RE: 1272 Viscaino Road -FMP Amendment -PLN220251

1272 Viscaino Road -FMP Amendment -PLN220251

Tree Assessment Forest Management Plan Mansur Residence

I am reaching out for some clarification regarding a Tree Assessment that you completed for Dan and Tricia Mansur at 1272 Viscaino Rd in Pebble Beach. Attached are the Tree Assessment, the amendment to the Tree Assessment and a site plan with the trees in question circled in red.

Drawing Title:
SITE PLOT PLAN

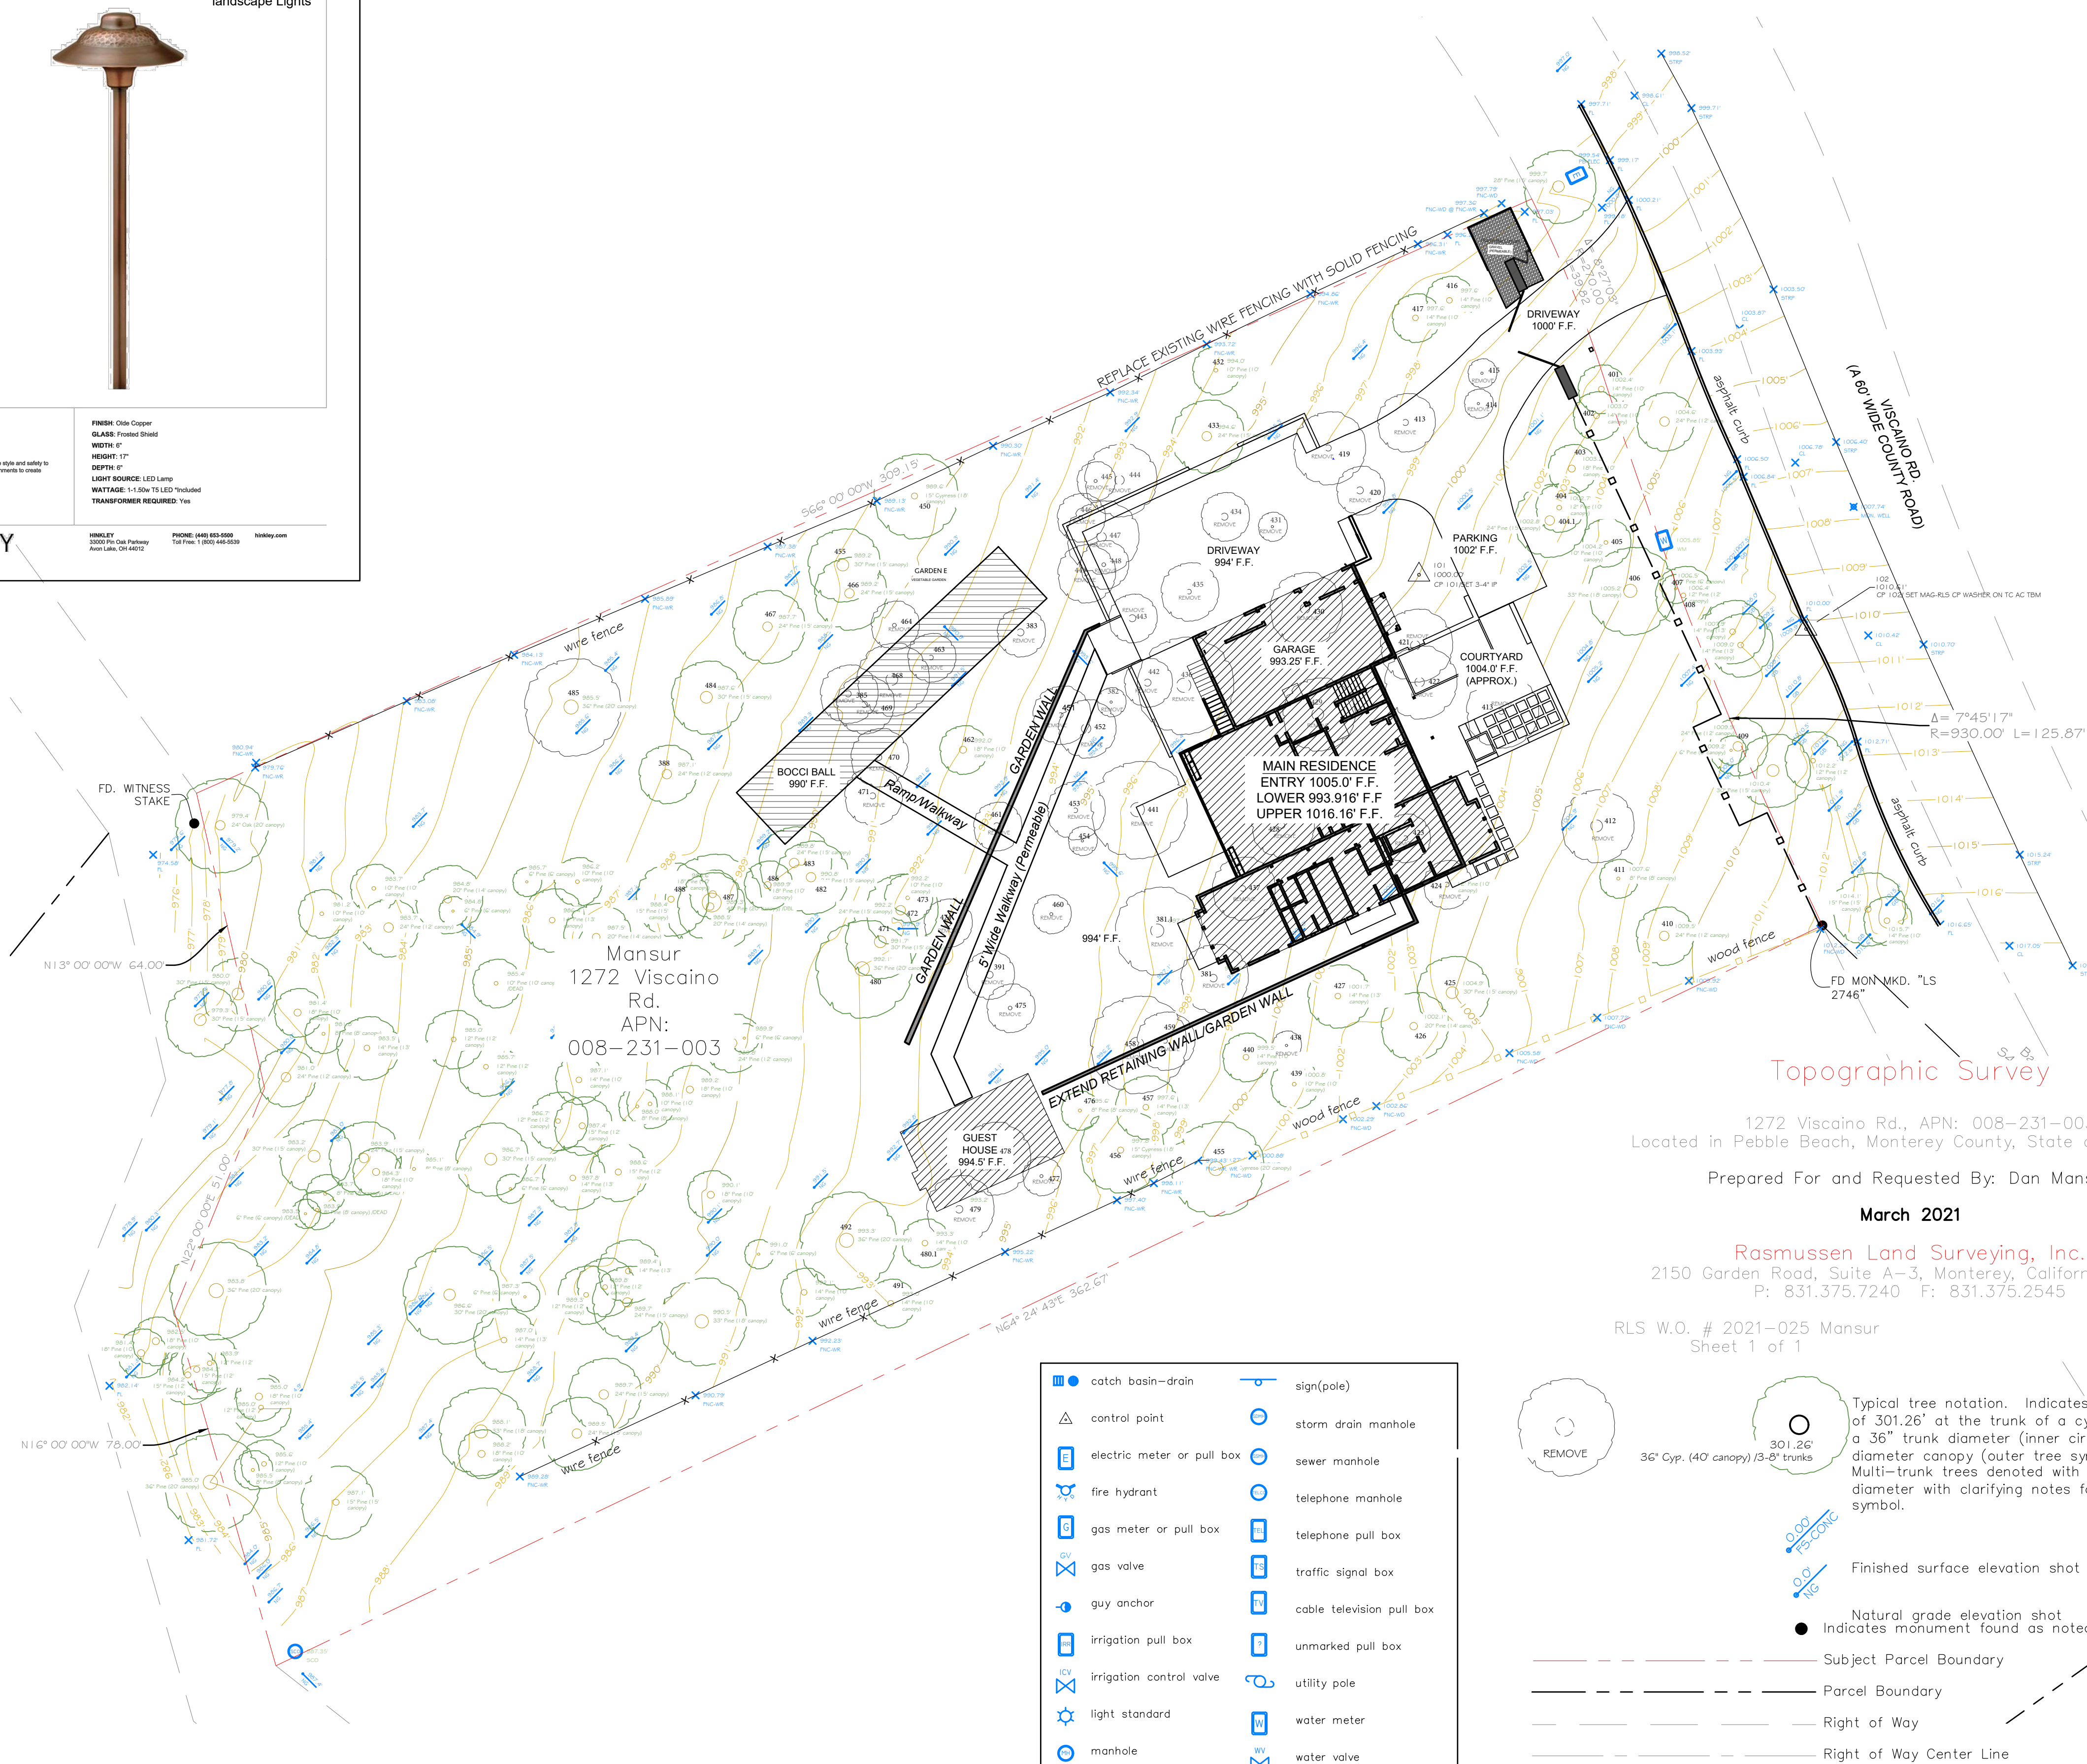
As the County Planner for this project, I must make the finding that the number of trees proposed for removal is the minimum under the circumstances. Approximately 30 to 35 trees are within the footprint of the house, patios and driveway or are directly adjacent to the proposed structure; these are justifiable under the circumstances.

There are about 15 trees that I'll need an explanation of why they are recommended for removal.

Tree 467, 466 and 465 are included on the removal list in the attached amendment dated 11/18/22. These trees are said to be in fair condition but are proposed for removal due to neighbor complaints. Can you please provide clarification if these trees will be impacted by the proposed development or are hazardous?

The other trees I have questions about include 425, 426, 433, 438, 441, 445, 454, 458, 459, 460, 461 and 470. From looking at the site plan, these 15 trees appear to be far enough away from the structure that they wouldn't be directly impacted. Please let me know if this is incorrect, my understanding is if the dripline of the tree is outside of the footprint of the development it can survive.

To help make the finding that these 15 trees must be removed for this development project to take place, I would appreciate it if you could please provide a little more detail regarding the individual trees and the recommendation for their removal.

I didn't have a grading sheet to study, but essentially grade changes are either accomplished by the placement of retaining walls or cutting the slope to re-establish the grade and improve water flow away from the structure. I am to understand that in this case, he is planning to install retaining walls; this will require soil overcut and removal of roots on trees that will not be accustomed to the newly exposed wind. As to stem bleeding, this is excessive resinosity, a product of pine pitch canker, a non-curable disease that has affected and slowly killed many of the pines in this forest.
